East Anglia ONE North and East Anglia TWO Offshore Windfarms

Updated Photomontages Clarification Note

Document Reference: ExA.AS-16.D3.V1

Plate 1: Updated East Anglia TWO and East Anglia ONE North Substation Rochdale Envelope 3D Model

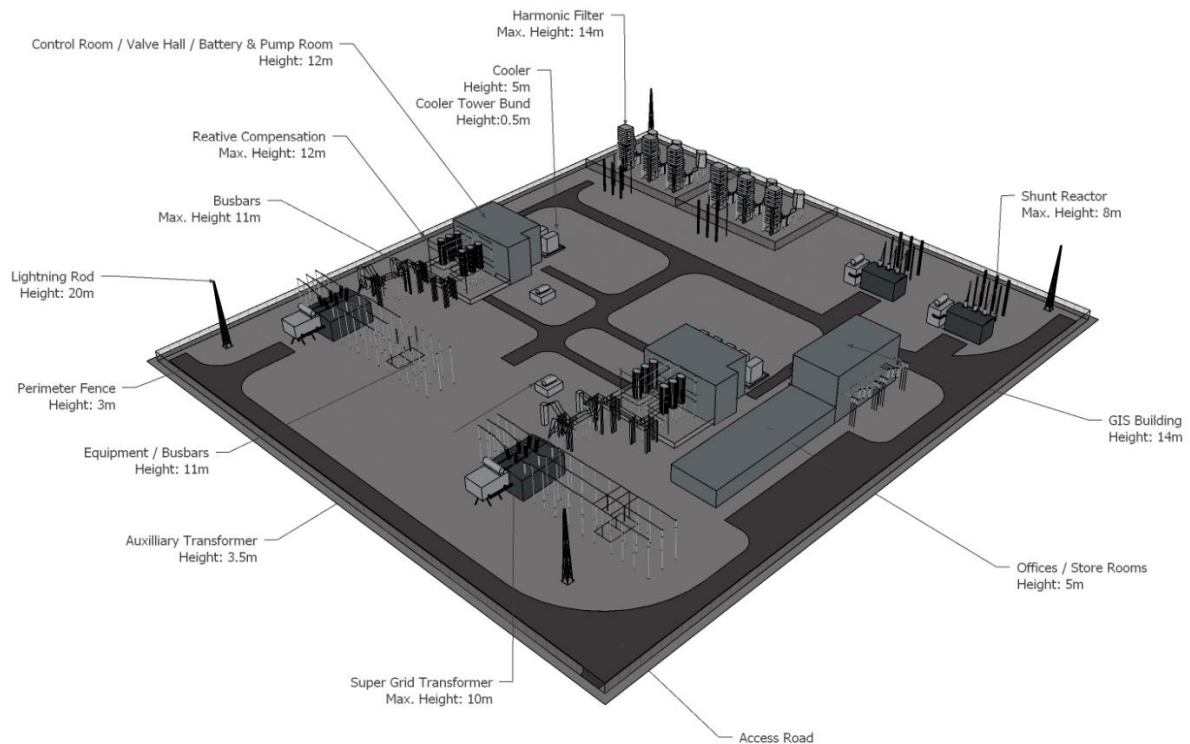
2. Suffolk County Council (SCC) and East Suffolk Council (ESC) (the Councils) provided comments on **Chapter 29 Landscape and Visual Impact Assessment** (LVIA) (APP-077) in their Section 56 response and these were discussed at a Statement of Common Ground (SoCG) meeting with the Applicants on 3rd March 2020. The Councils also provided comments on the photomontages in Appendix 3 to their **Joint Local Impact Report** (LIR) (REP1-132). This clarification note seeks to resolve any matters within the Councils comments regarding the visualisations provided as part of **Chapter 29** (APP-077), for any clarifications to be set out, or for updates to be made to visualisations where required.

17. The Rochdale Envelope for the onshore substations shown in the updated visual representations is described in the **Onshore Substations Update Clarification Note** submitted at Deadline 3 (document reference ExA.AS-11.D3.V1) and illustrated in **Plate 1** (East Anglia ONE North and East Anglia TWO) below. The

Plate 3.1: Viewpoint 1 - 3D VNS model view used to test screening in view

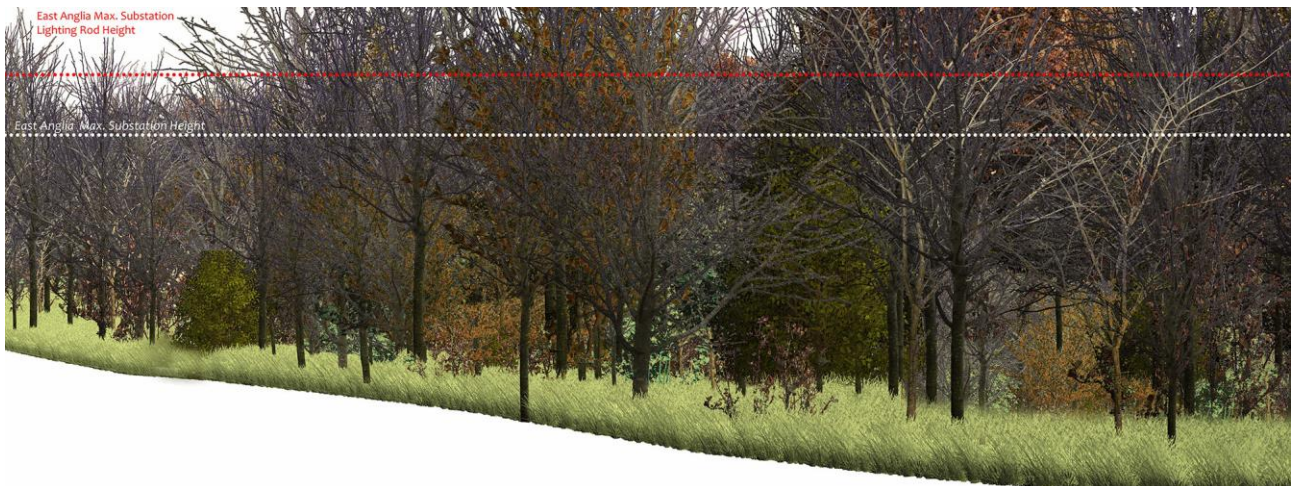
38. In its LIR (REP1-132), and raised at the SoCG meeting, the Councils have provided the following comments with reference to Viewpoint 1 (**Figure 29.13**) (APP-404):
- The image shows significant stem diameter typical of a tree that is 40 – 50 years old.
 - Significant lateral limb growth, again typical of a tree that is 40 – 50 years old.
 - Suggestion of secondary natural regeneration not usually found in recently planted woodland of only 15 years age.

42. The visual representation in **Figure 29.13c** (APP-404) is representative of the height and full screening predicted by the proposed woodland planting at very close range at 15 years. The height of the woodland has been tested further with reference to the 3D VNS model view used to inform the production of Viewpoint 1 (shown below in **Plate 3.1**). The maximum onshore substation height is illustrated by the white dashed line in the below image, with the lightning rod height (25m) shown with the red dashed line, with the substation height screened entirely behind the woodland planting (edge woodland and core woodland with heights ranging between 2m-7.8m at 15 years).
